Process Sheet

Customer	: CU-DAR001 Dart Helicopters Services	Drawing Name	: 350 SKIDTUBE ASSEMBLY LH
Job Number	: 40697		
Estimate Number	: 10262		
P.O. Number	:	Part Number	: D350636011
This Issue	: 22/07/2008 S.O. No. :	Drawing Number	: D2750 UNDER REVIEW <i>PH 03.07.22</i>
Prsht Rev.	: NC	Project Number	: N/A <i>UPDATE PER DSI 9413</i>
First Issue	: 11 Type : SKIDTUBES	Drawing Revision	:
Previous Run	: 39972	Material	:
Written By	:	Due Date	: 10/08/2008 Qty: 1 Um: Each
Checked & Approved By	: <i>JUD 08.7.22</i>		
Comment	: Est Rev: I 02.09.25 Rearranged procedure steps KJ : Est Rev: J 06-03-23 As per Rev D JLM : Est Rev: K 06-07.13 As per dsi9343 EC : Est Rev: L 07-07-28 Added SS Wearplates(Rev E) JLM : Verified By: EC : Est Rev: M 08-04-22 update steps 4, 13 DD verified by: EC

DART**DART SERVICE INSTRUCTION**

A	NEW ISSUE	PH	08.05.14
REV.	DESCRIPTION	BY	DATE
DESIGN	PH	DART AEROSPACE USA, INC PORT HADLOCK, WA	
DRAWN	PH		
CHECKED		DRAWING NO.	REV. A
MFG. APPR.	N/A	DSI 9413	SHEET 1 OF 3
APPROVED		TITLE	SCALE
DE APPR.		WEARSHOE MODIFICATION	NTS
DATE	08.05.14	COPYRIGHT © 2008 BY DART AEROSPACE USA, INC THIS DOCUMENT IS PRIVATE AND CONFIDENTIAL AND IS SUPPLIED ON THE EXPRESS CONDIT

WAS**NOW****FIGURE 1 - WEARPLATE MODIFICATION**

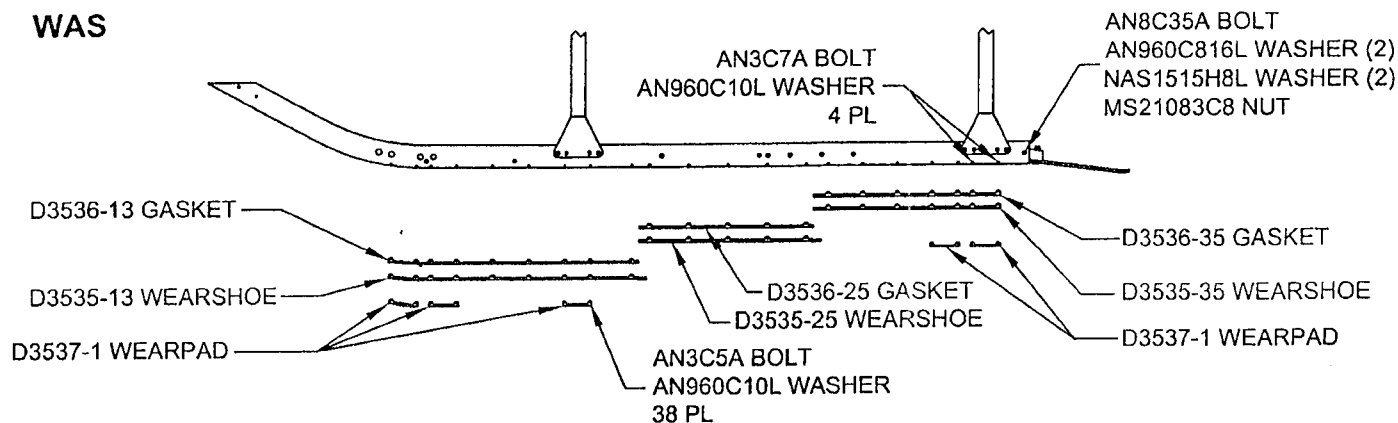
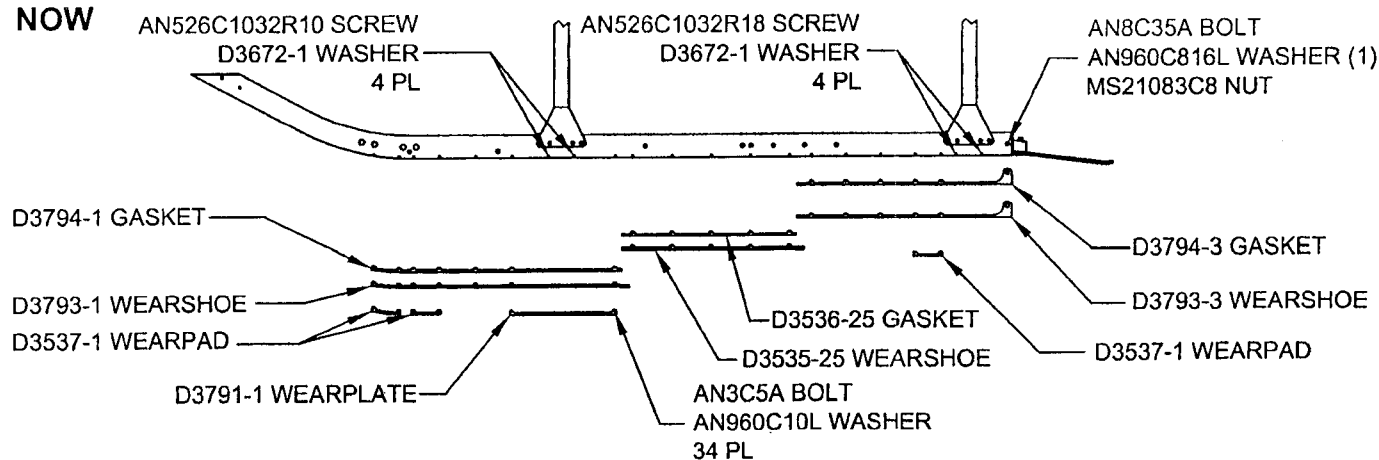
THE WEARPLATES ON D350-636-011/-012/-013/-014 SKIDTUBES AT CHG 004 (AND LATER) HAVE BEEN MODIFIED AS SHOWN IN FIGURE 1 BELOW TO ELIMINATE THE POSSIBILITY OF INTERFERENCE BETWEEN THE WEARPLATES AND CROSSTUBE SADDLES AT INSTALLATION. THERE IS NEGLIGIBLE WEIGHT CHANGE ASSOCIATED WITH THIS MODIFICATION.

(AN526C1032RXX SCREW LOCATIONS NO LONGER USED TO MOUNT WEARSHOES)

TO INSTALL THE DSI 9413-011 KIT, REMOVE THE EXISTING WEARSHOES/GASKETS UNDER THE FWD/AFT SADDLES AND INSTALL NEW WEARSHOES/GASKETS AS SHOWN IN FIGURE 1. PLUG UNUSED HOLES WITH AN526C1032RXX SCREWS AND D3672-1 WASHERS. INSTALL SCREWS WITH SIKAFLEX -241/-291 OR PROSEAL 890 OR MIL-S-8802 CLASS 'B2' SEALANT AS SHOWN IN FIGURE 1. NOTE: SOME OF THE PREVIOUSLY INSTALLED HARDWARE IS NO LONGER REQUIRED.
